Model: Bellini LCT		Date: 25-Apr-00	No.: MB303001
Modified Article: Noise Absorber Seal		Prepared by: H.K.	
From: Technical Services Dept., GTS Division			
Reason for Modification:	<input type="checkbox"/> Parts catalog correction	<input type="checkbox"/> Vendor change	<input type="checkbox"/> To meet standards ()
	<input type="checkbox"/> To facilitate assembly	<input type="checkbox"/> To improve reliability	
	<input type="checkbox"/> Part standardization	<input checked="" type="checkbox"/> Other

Model: Bellini LCT		Date: 29-May-00	No.: MB303002
Modified Article: Felt Wick Spacer & Flange		Prepared by: H.K.	
From: Technical Services Dept., GTS Division			
Reason for Modification:	<input type="checkbox"/> Parts catalog correction	<input type="checkbox"/> Vendor change	<input type="checkbox"/> To meet standards ()
	<input type="checkbox"/> To facilitate assembly	<input type="checkbox"/> To improve reliability	
	<input type="checkbox"/> Part standardization	<input checked="" type="checkbox"/> Other

Model: Bellini LCT		Date: 06-Jul-00	No.: MB303003
Modified Article: Side Plate Bracket		Prepared by: H.K.	
From: Technical Services Dept., GTS Division			
Reason for Modification:	<input

Noise Absorber Seal

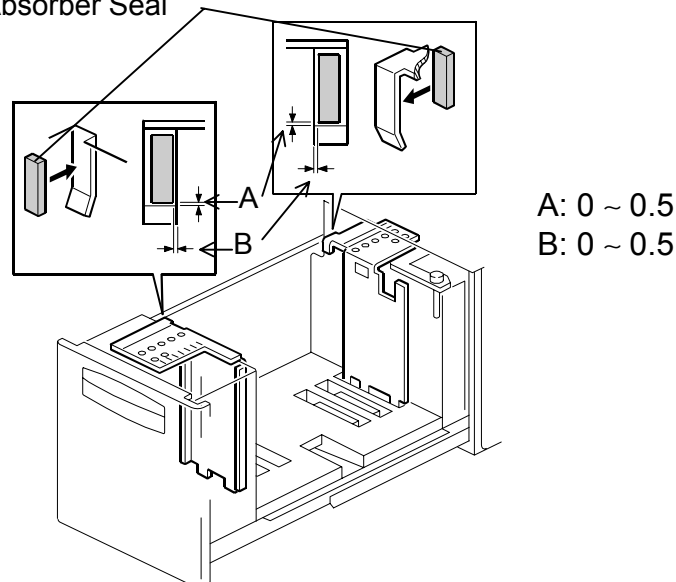
To minimize the feeding noise from the LCT, a noise absorber seal has been stuck on the reverse side of each side fence (three feed trays, front and rear: total 6 pcs).

Diagram No.1

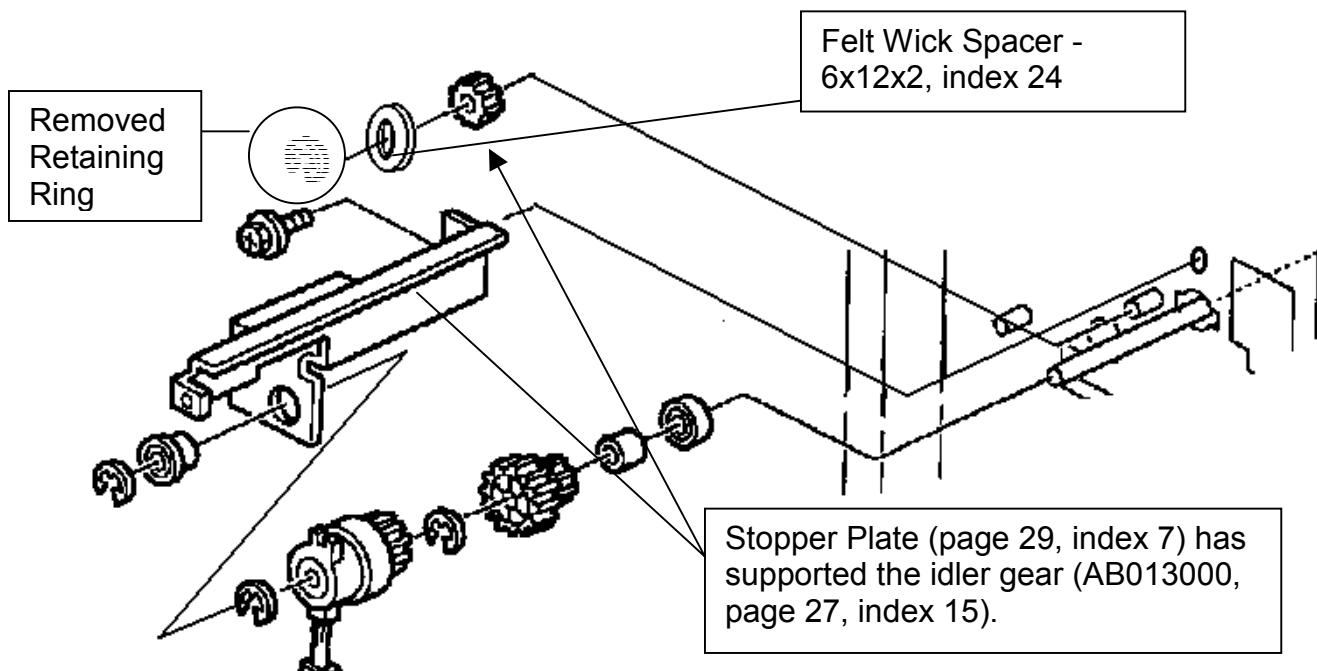
When the LCT was connected to the 105 cpm machine in a laboratory test, noise was generated from the thrust gap between the relay clutch and idle gear because of the higher paper feed speed. To correct this, a felt wick spacer has been added and one retaining ring has been removed. The idler gear (AB013000) is now supported by the stopper plate instead of the removed retaining ring.

Diagram No.2

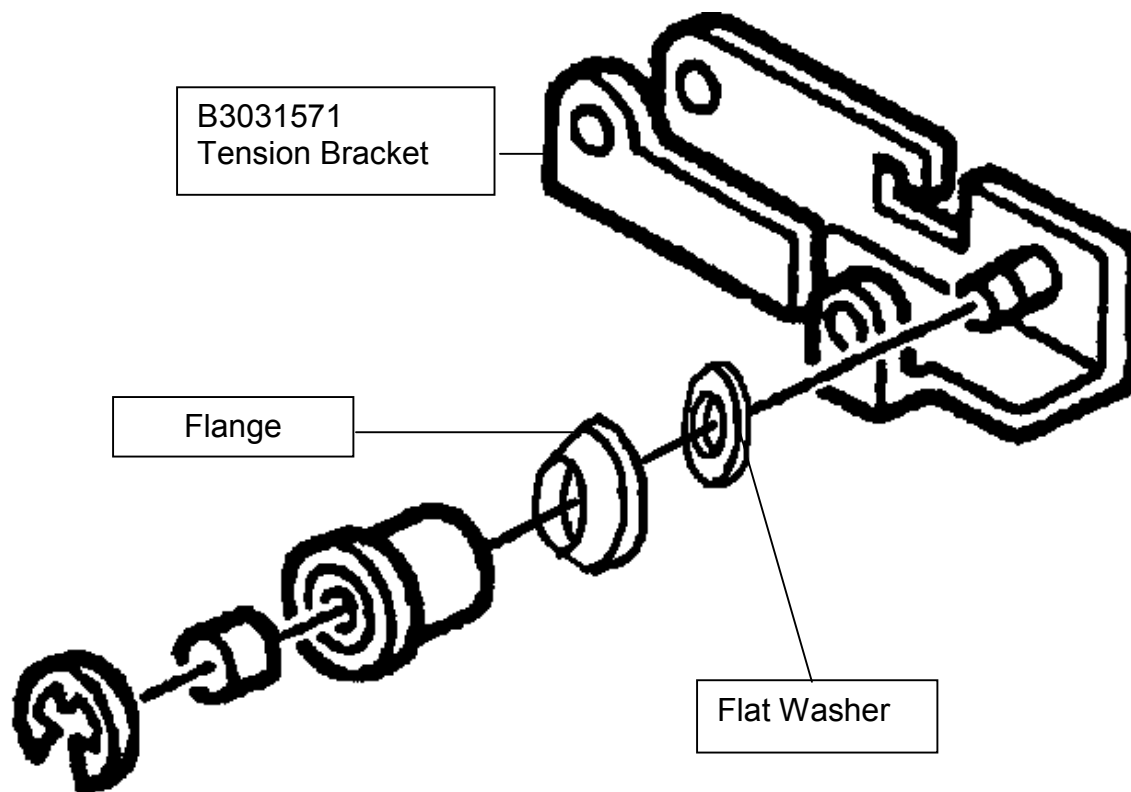
When the LCT was connected to the 105 cpm machine in a laboratory test, the timing belts tended to slip off the idler pulley. To correct this, a flange and a flat washer have been added to each tension bracket (B3031571, page 27, index 14 and page 29, index 15).

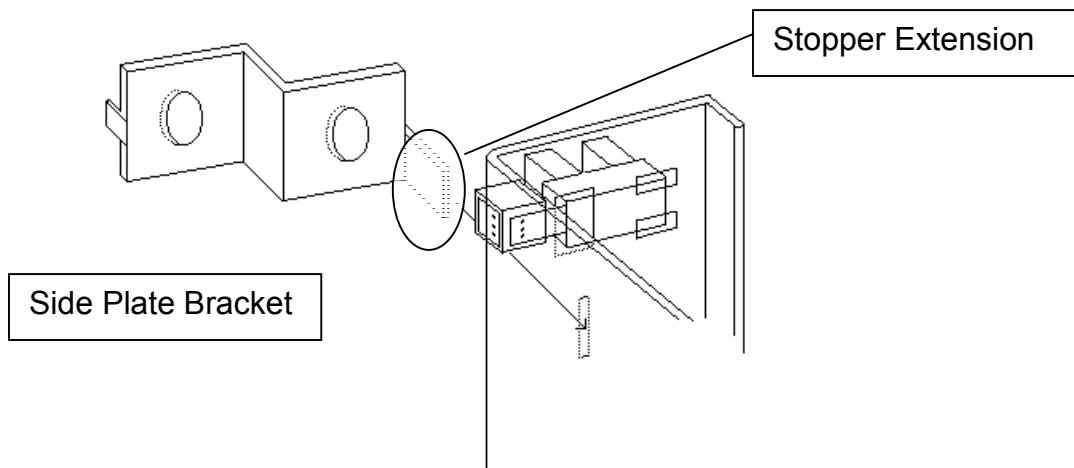
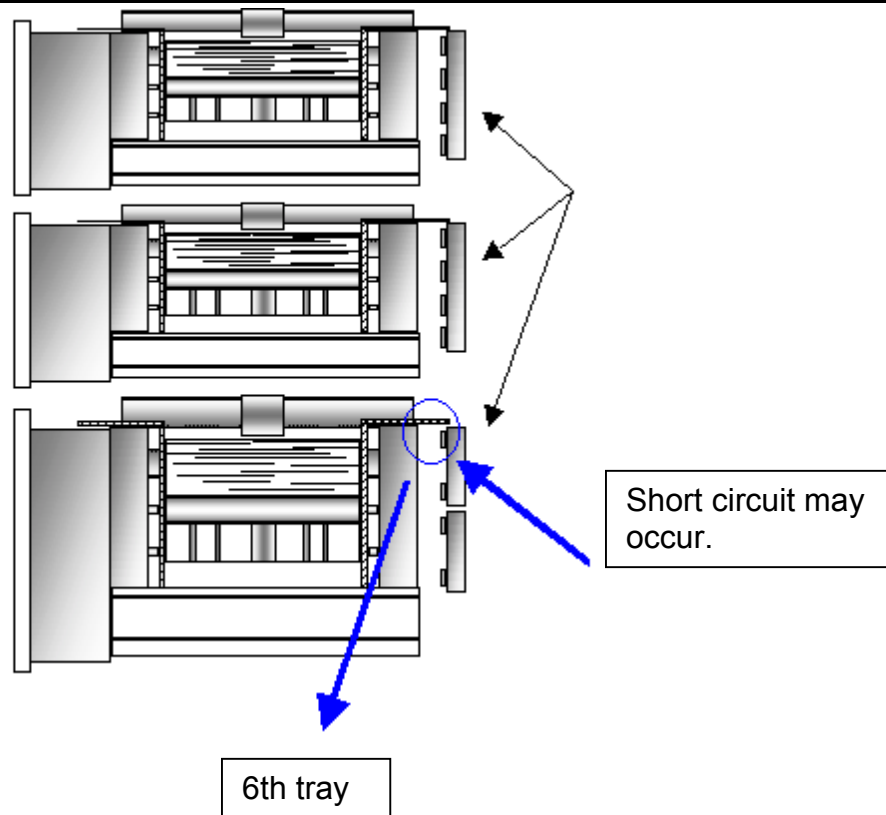
If Tray 6 (2550-sheet tray) with a large amount of paper is forcibly pushed into the LCT main body, the rear LCT side plate may be temporarily bent. This may cause the side plate bracket to touch the paper height sensors, which can sometimes result in a short circuit or damage to the sensors. To correct this, a stopper extension has been added to the side plate bracket. Therefore, even if the above situation occurs, the side plate bracket is stopped by the stopper extension. This will ensure that the bracket does not touch the sensors.

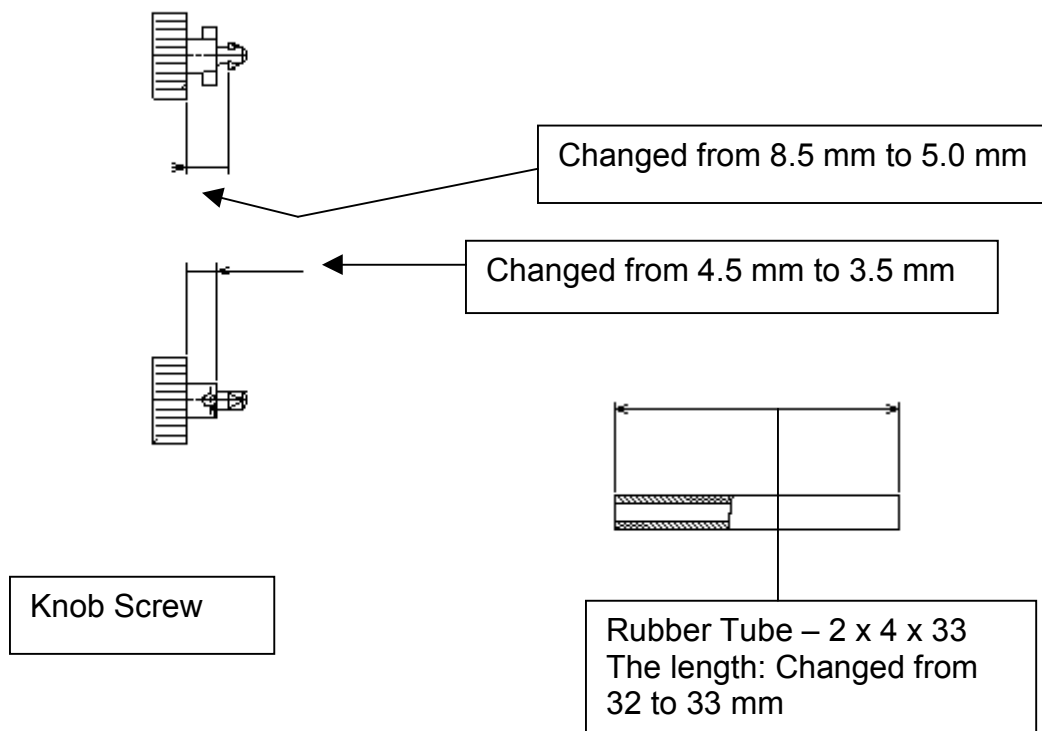
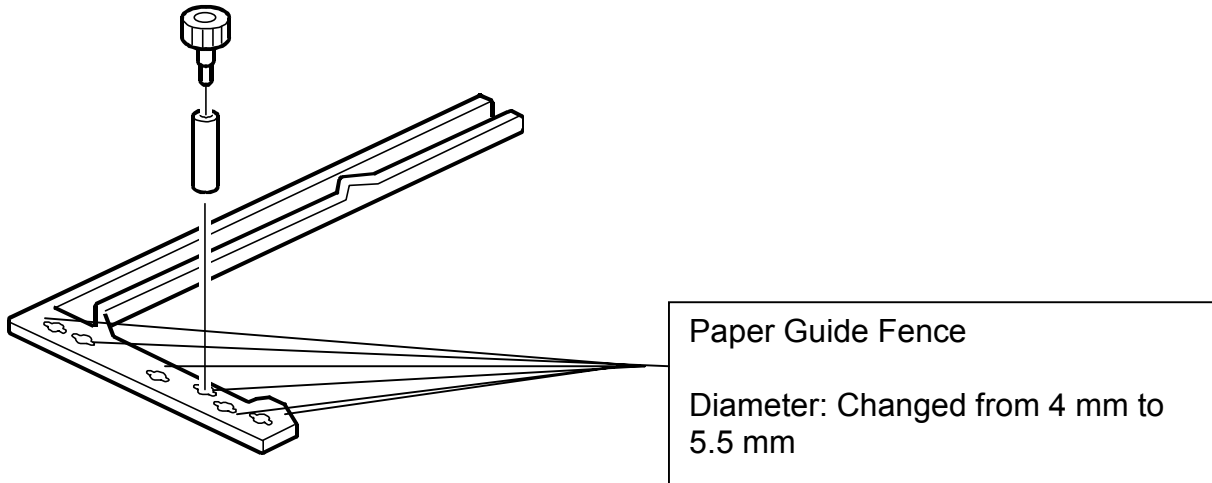
When changing the paper size, operators have to change the position of the end fence (Knob Screw with Rubber Tube). When the operator installs the end fence in the hole in the paper guide fence incorrectly, the top of the end fence is higher than normal. The end fence may tend to be broken by the tray front cover when the tray is pulled out. To improve the durability of the end fence, the production machines have been modified as follows:

1. The knob screw has been made shorter.
2. The rubber tube has been made 1 mm longer.

3. The diameter of the holes for inserting the end fence (Knob Screw with Rubber Tube) in the Paper Guide Fence has been changed from 4 mm to 5.5 mm.

Note: When replacing any of the old parts in the field, install all three new parts as a set.

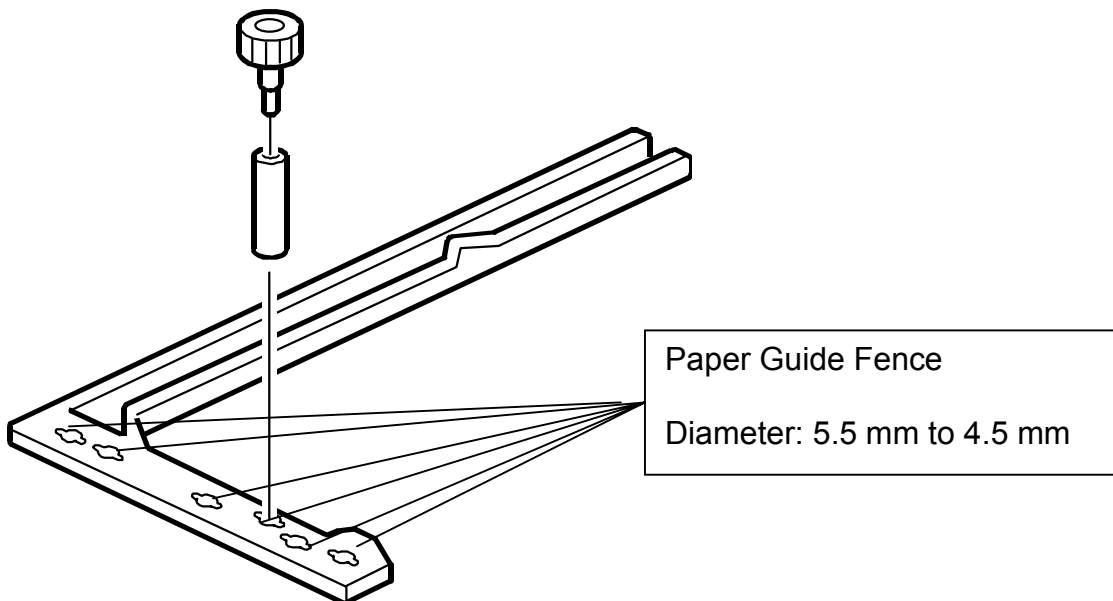
The end fence may drop due to vibration during transportation. The diameter of the holes in the paper guide fence for inserting the end fence (Knob Screw with Rubber tube) has been changed from 5.5 mm to 4.5 mm.

B3032781 (4 mm diameter)

B3032786 (5.5 mm diameter)

B3032789 (4.5 mm diameter)

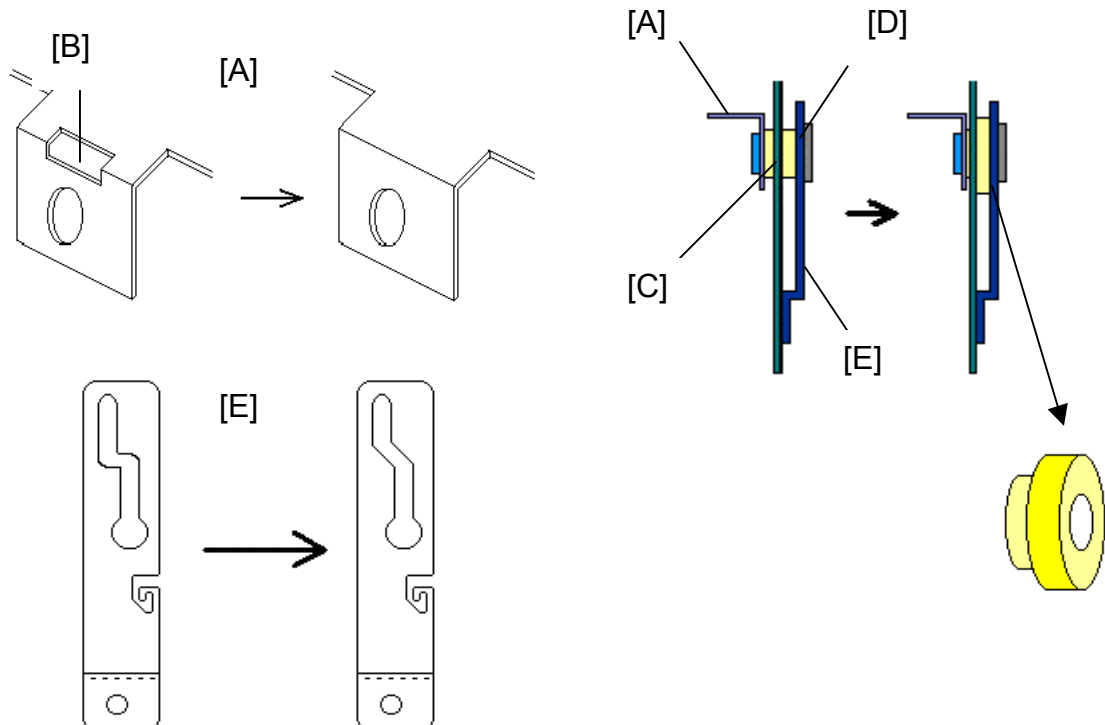
To improve the durability of the LCT guide plate open/close mechanism (for U3 jam removal), the following modifications have been applied:

1. The length of the guide plate [A] (B3033645) has been increased by 1 mm to remove the play between the guide plate and the frame. Also, cutout [B] has been removed to strengthen the plate.
2. Collar [C] and stepped screw [D] have been changed to remove the space between the frame and the linkage bracket [E].
3. The shape of the linkage bracket [E] has been changed to ensure smoother movement of the guide plate. Along with this modification, the tension of the tighten spring (AA060830) has been increased.

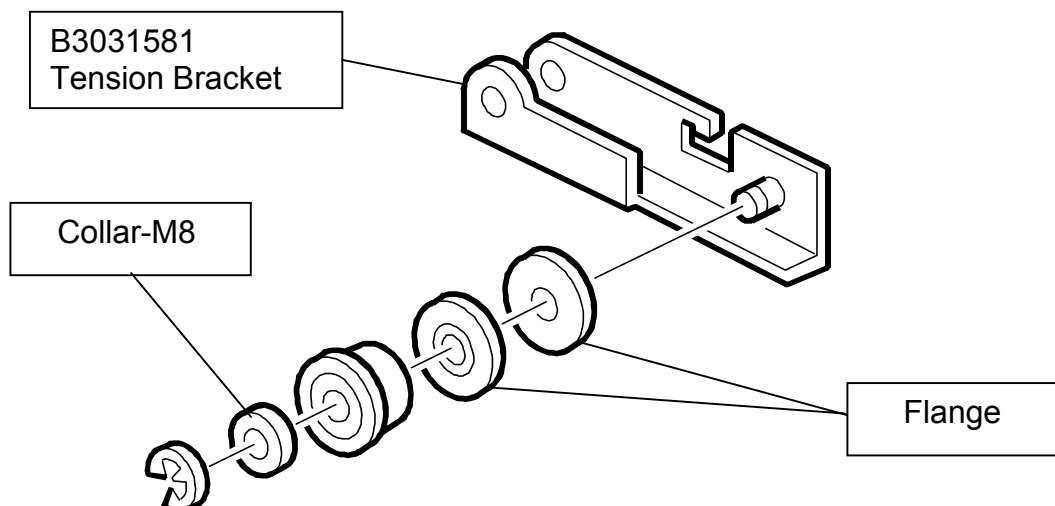
The tension bracket can sometimes contact the flat washer when the LCT is used, generating noise. To correct this:

1. The flat washer has been changed to a flange, so that two flanges are now used.
2. The bushing has been changed to a collar.
3. The shape of the tension bracket has been modified.

*1: These parts should be replaced as a set.

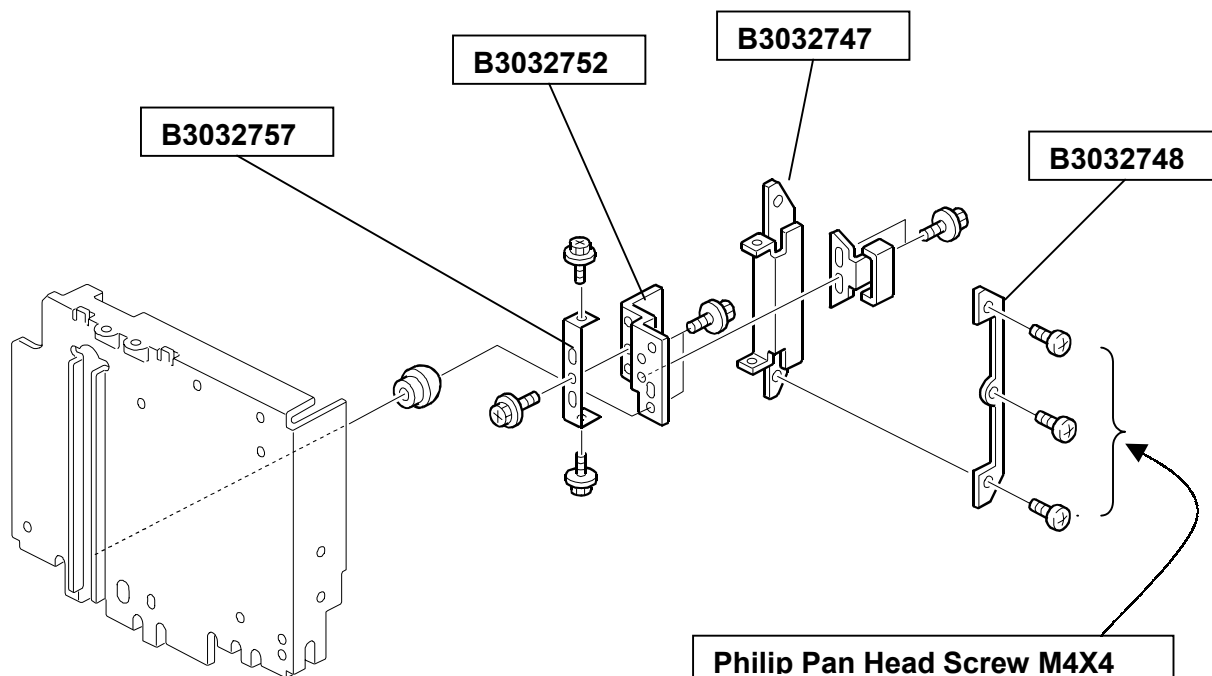
To prevent the spring plate from being broken, an actuator cover (B3032748) has been added to the paper actuator (B3032747).

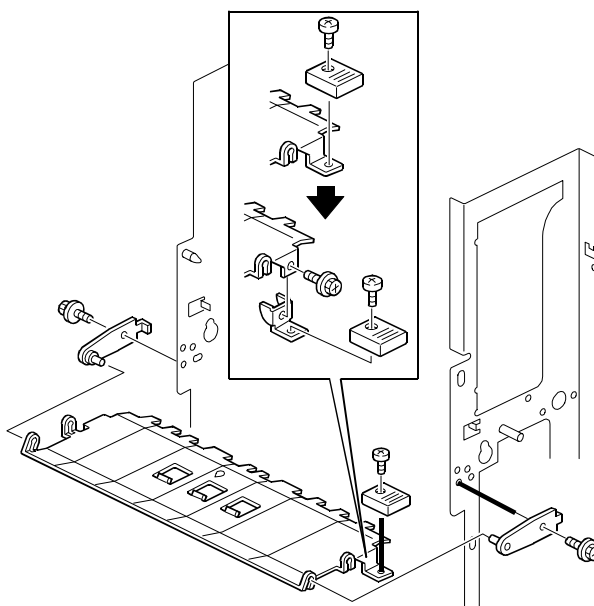
Sometimes slack develops in the B3033698 guide plate, which can then contact the transport roller and wear down its surface. To ensure that this does not occur:

1. The shape of the B3033698 guide plate has been changed.
2. The shape of the B3033635 guide plate has also been changed. In addition, the lever which was previously part of this plate has been attached as an individual part, strengthening this area. A tapping screw has been added for attachment.

*1: These parts should be replaced as a set.

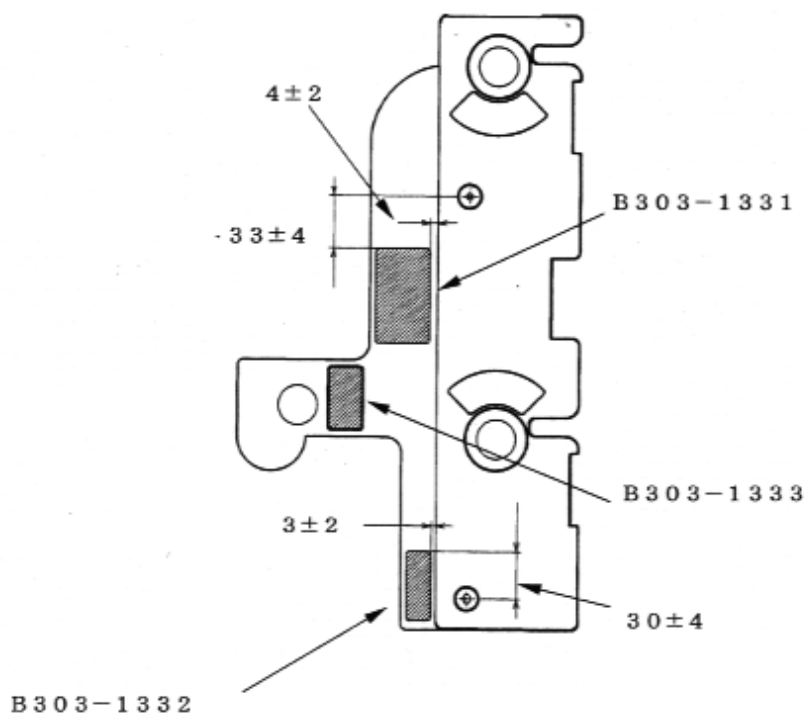
To make sure that customers turn the jam removal levers in the correct direction, the following decals have been added.

*1: All three decals should be replaced together.

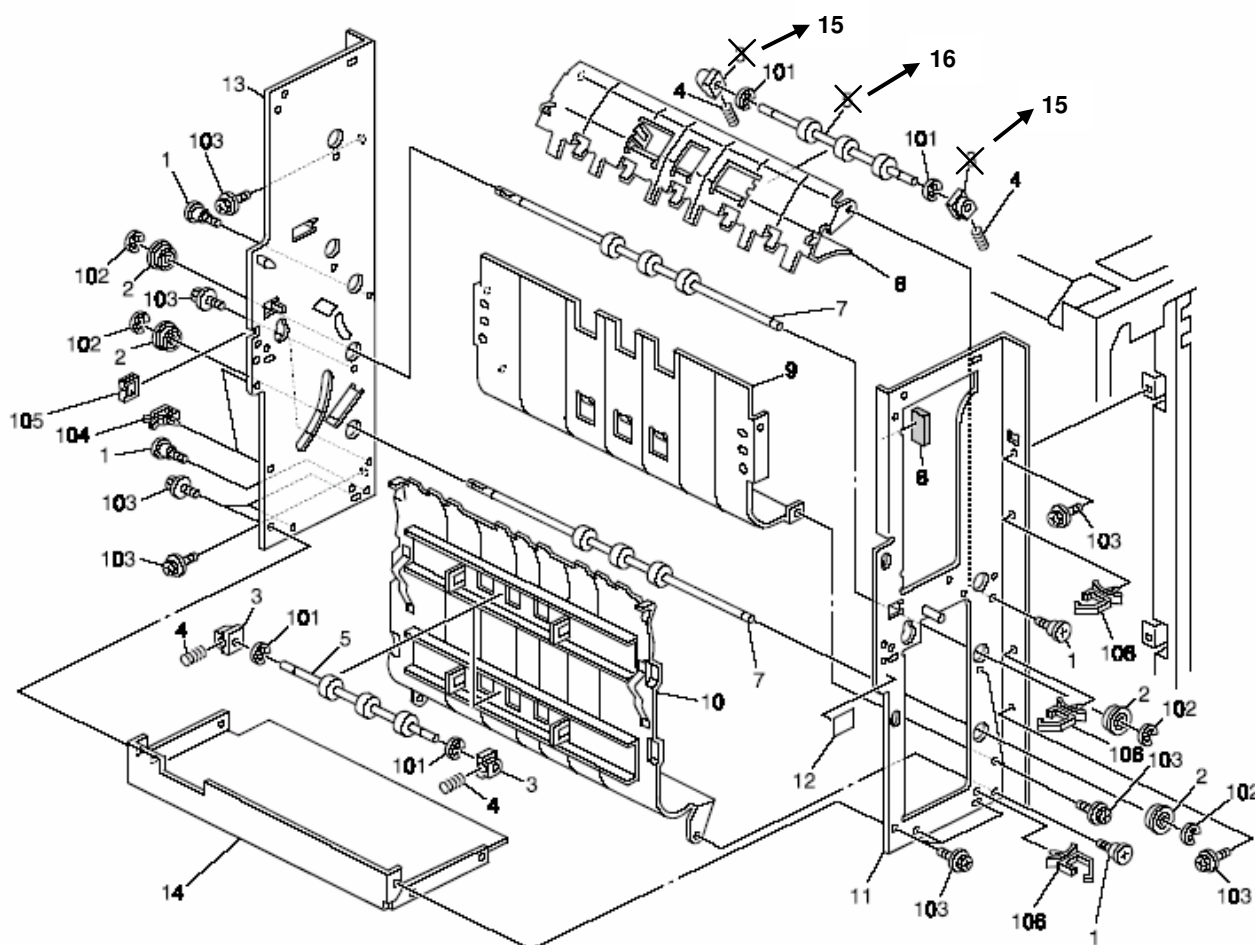
Reason/Change: Parts standardization with ALASKA-C.

Important: If you need to install any of the new parts labeled “**” for the first time, install them **together as a set**.
